Lake Merritt Station Area Plan

Final Environmental Impact Report

July 2014

Prepared for the **City of Oakland** by

Figure 2.1-2
Planning Boundary

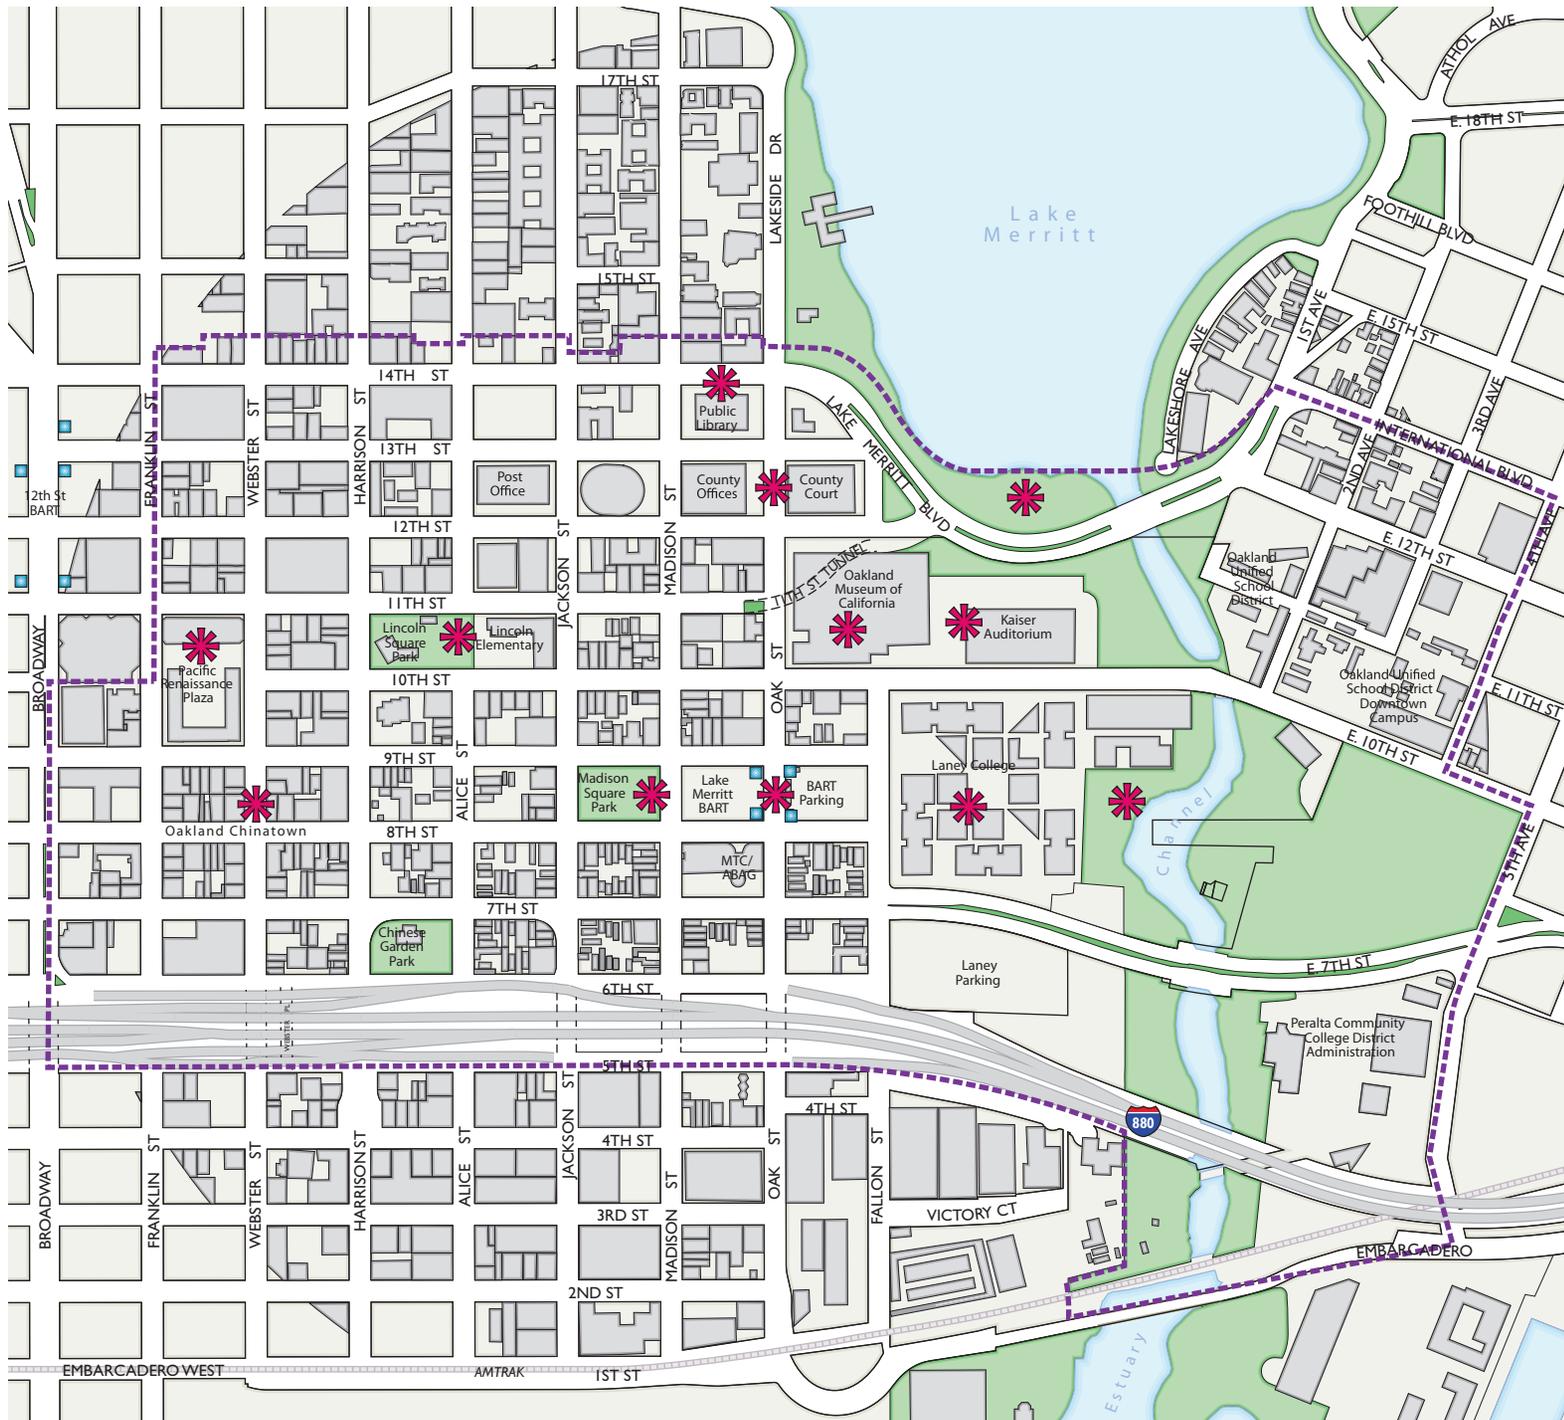
- Figure 2.1-2: Planning Boundary is revised, removing the numbers from the map. These numbers refer to “Key Assets” shown as symbols on the map. The map key identifying those “key assets” is not included in the EIR map, so the numbers should be removed.

Figure 2.3-1
Draft Area Character

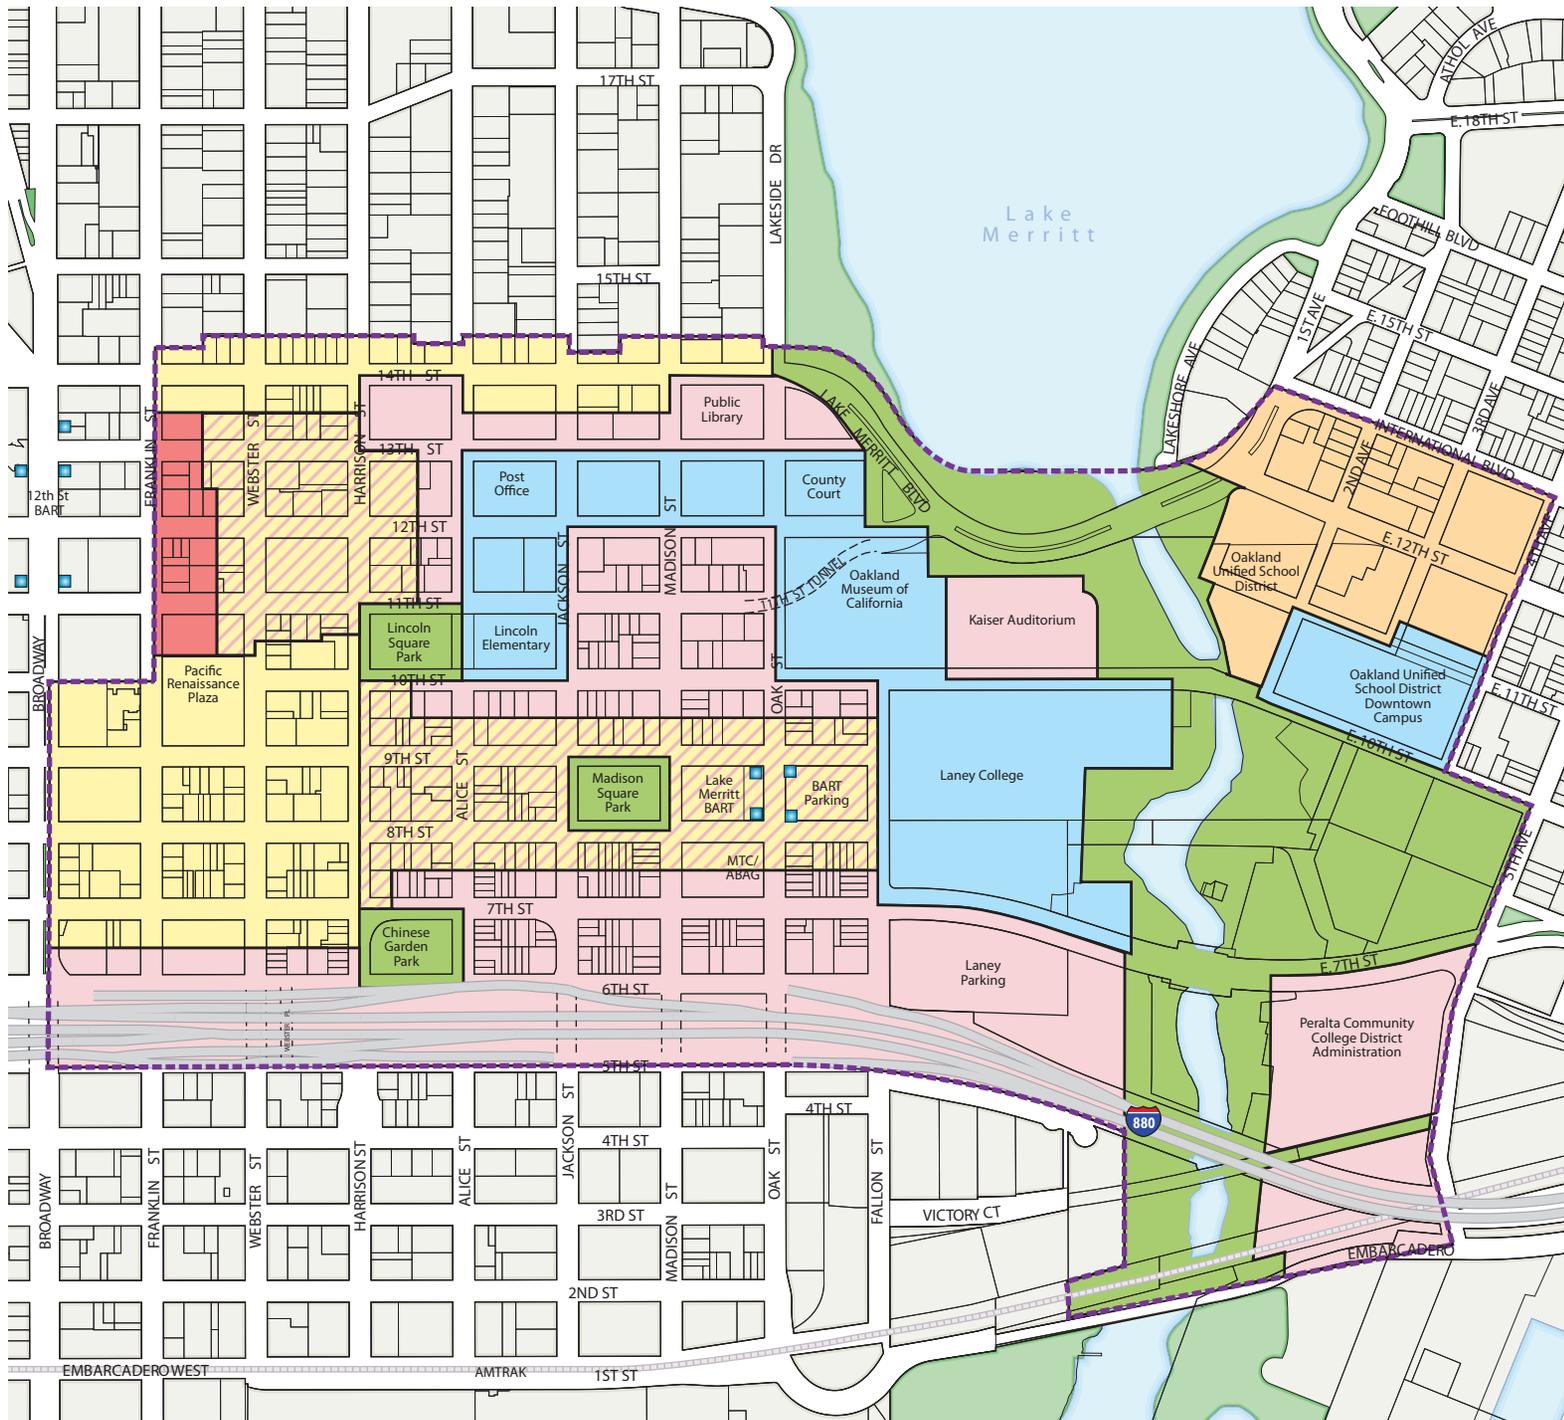
- Figure 2.3-1: Draft Area Character is revised to extend the Open Space district further from the Channel between I-880 and 7th Street.
- Figure 2.3-2: Draft Proposed Height Areas is revised to reflect the Plan changes described in Chapter 2 of this FEIR.

Figure 2.3-2
Draft Proposed
Height Areas

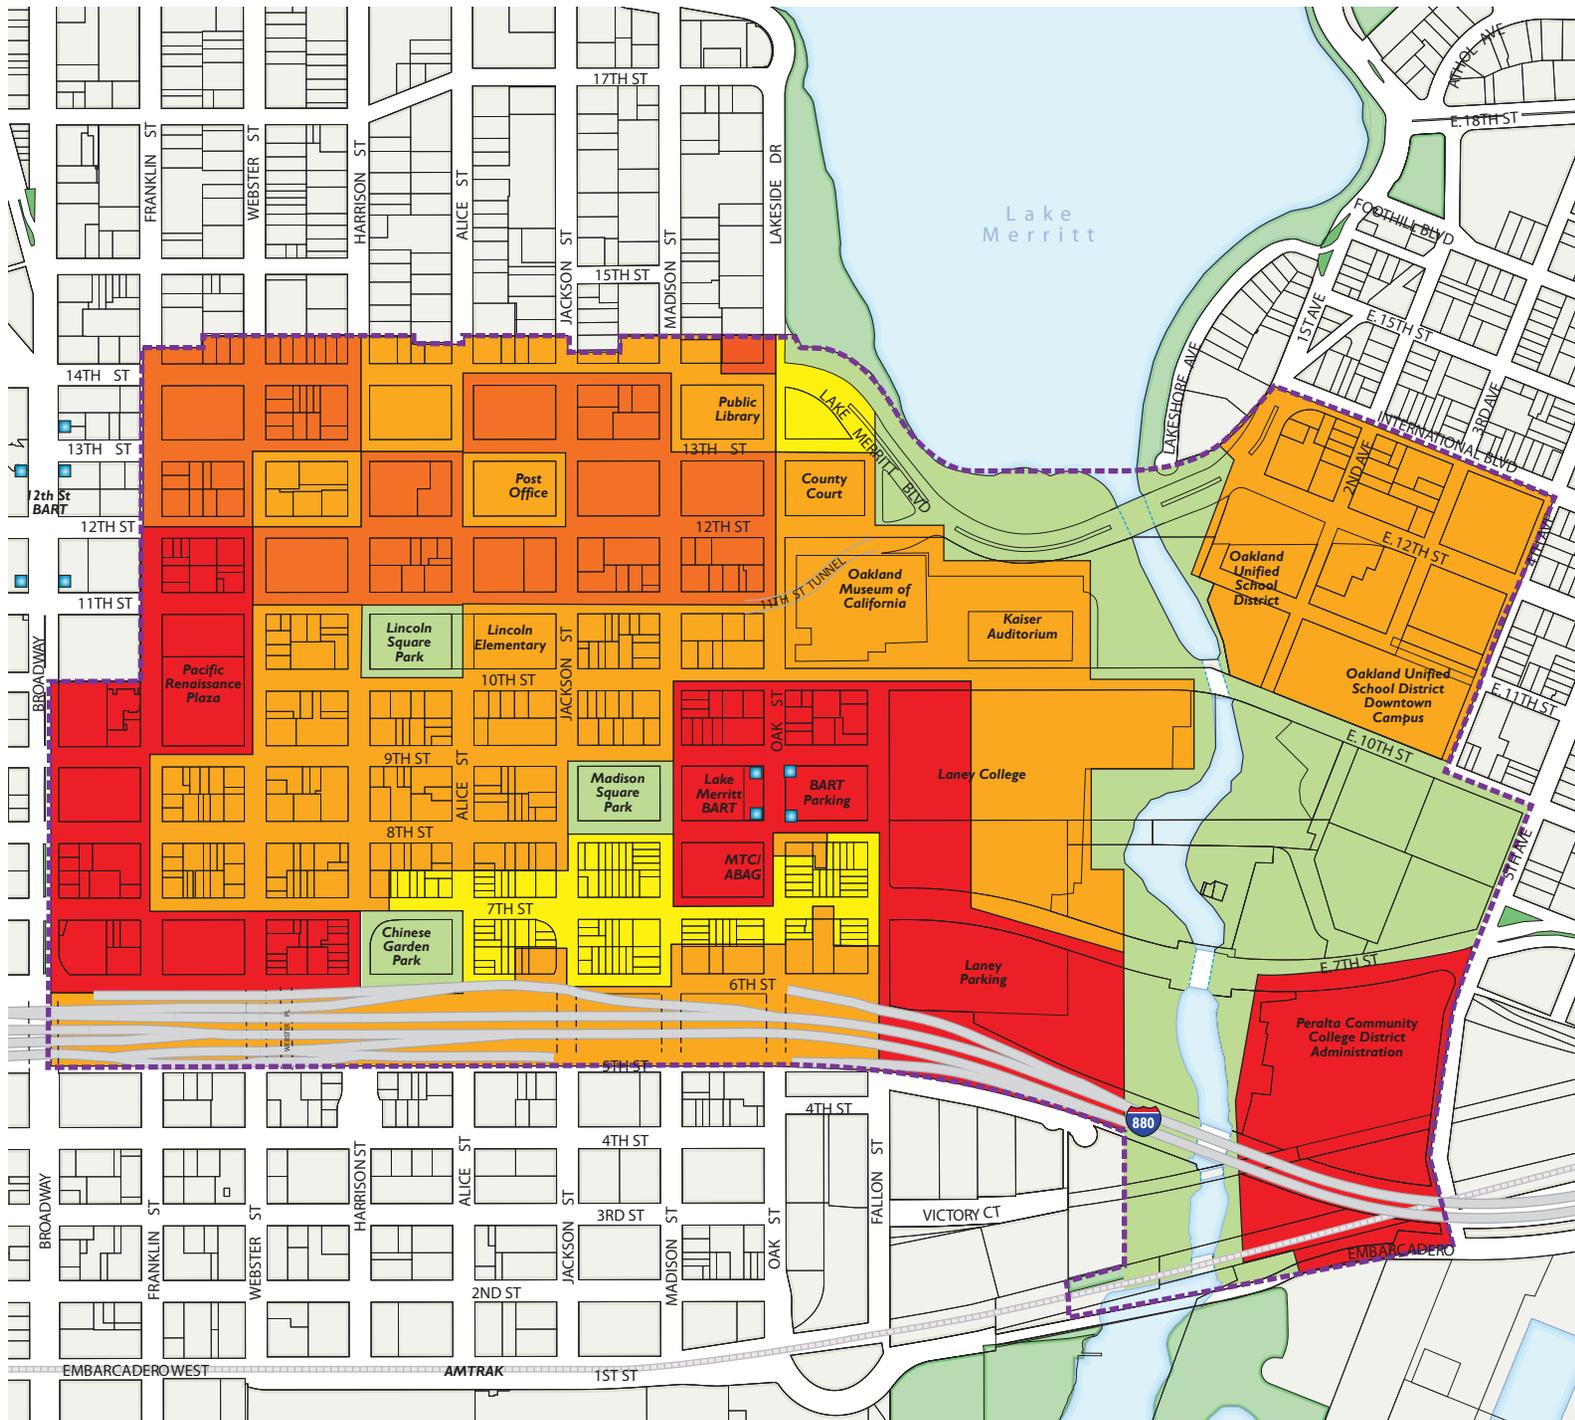
Figure 2.3-2: Draft Proposed Height Areas is revised to reflect the Plan changes described in Chapter 2 of this FEIR.

Figure 2.3-3
Phase I
Circulation Improvement

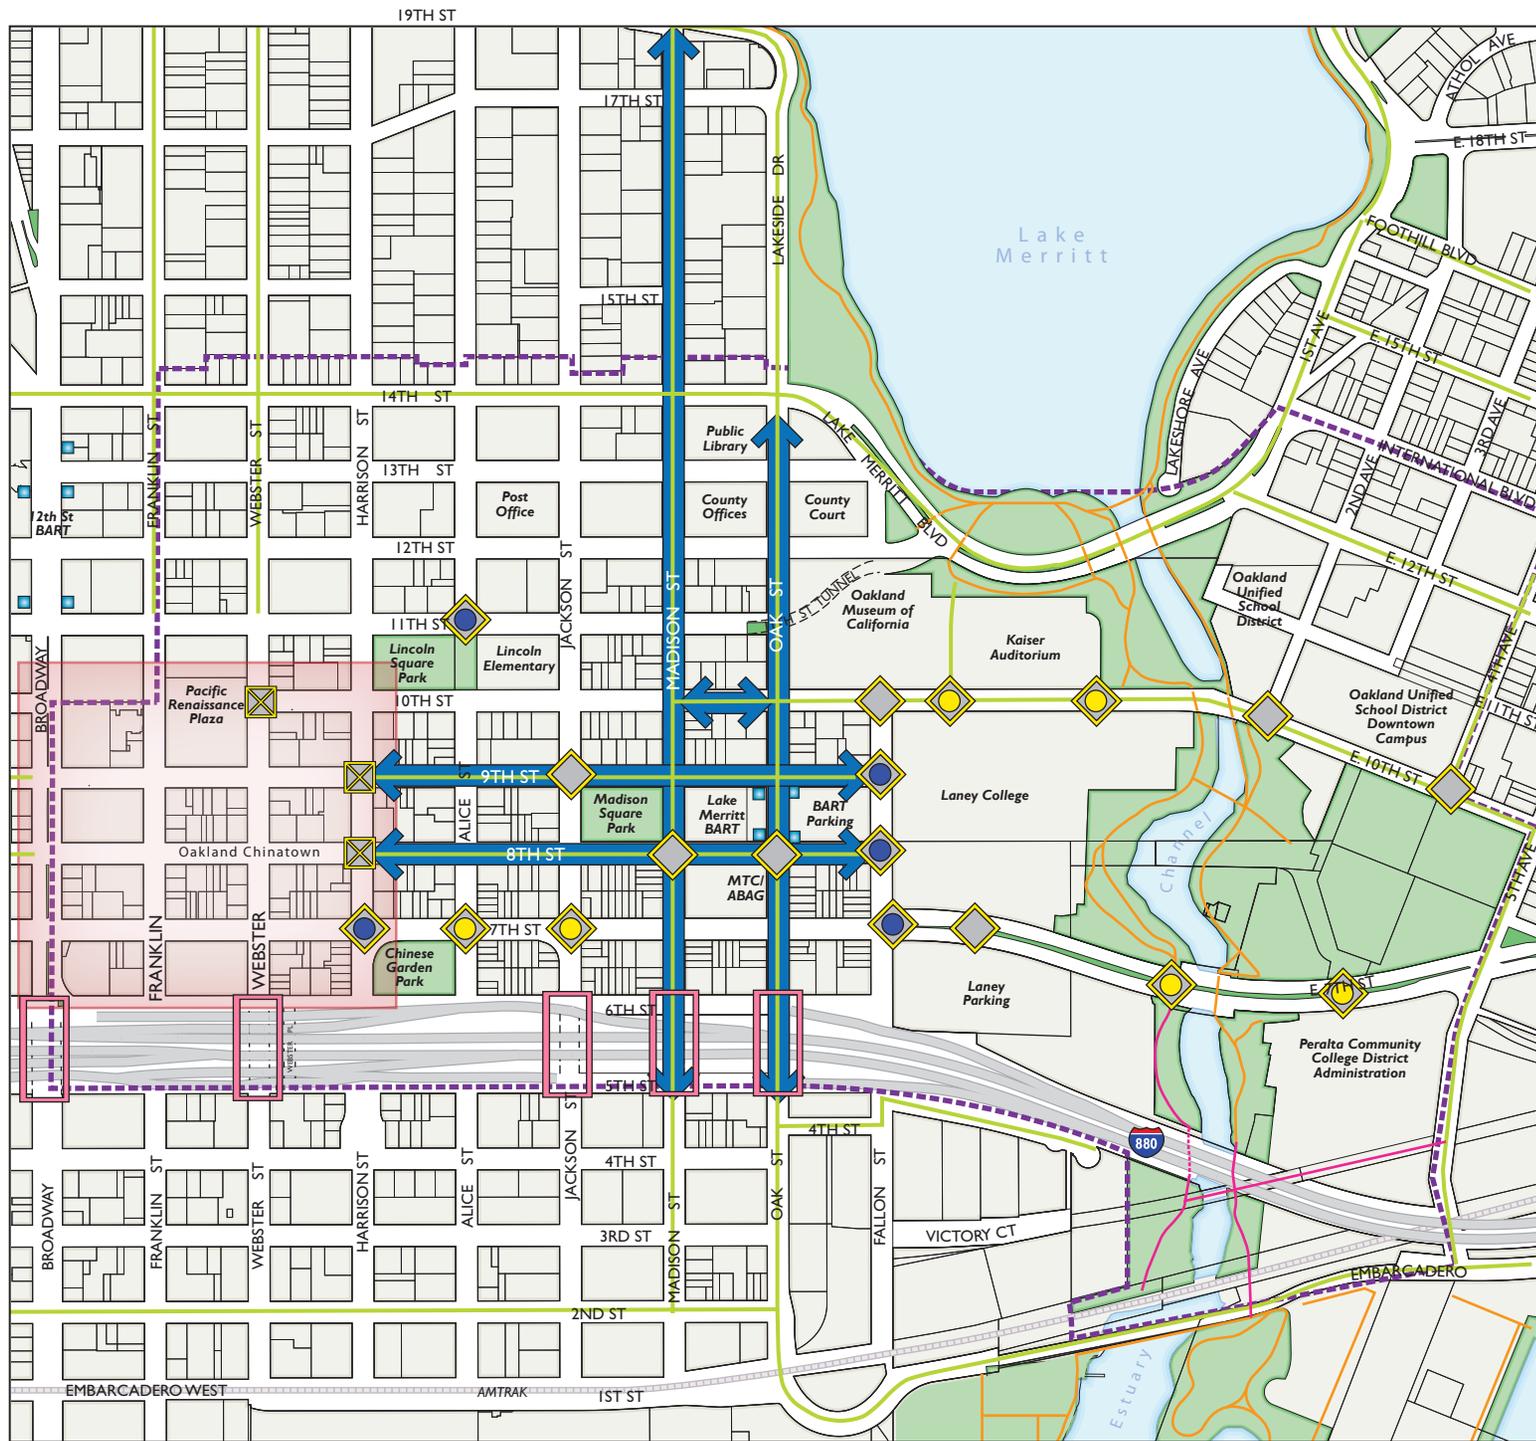
- Figure 2.3-3: Phase I Circulation Improvement is revised to add proposed improvements to the intersection of 7th and Jackson Streets, and make the Planning Area boundary symbol consistent with other maps.

The DEIR indicates that the City is planning bulb outs or sidewalk widening at 7th and Harrison. DEIR at Figure 2.3-3. This intersection lies at the mouth of the Tubes. The DEIR fails to analyze the transportation impacts of this improvement on traffic exiting the tubes.

- A8-18: As shown in Figure 2.3-3 of the DEIR, bulb outs at 7th and Harrison are being considered as a Phase I action to reduce crossing distances for pedestrians at this location. Phase I transportation improvements are not expected to have any significant adverse impact on the environment, since they do not involve changes to lane configurations, thus causing no adverse changes to circulation for any mode of travel.
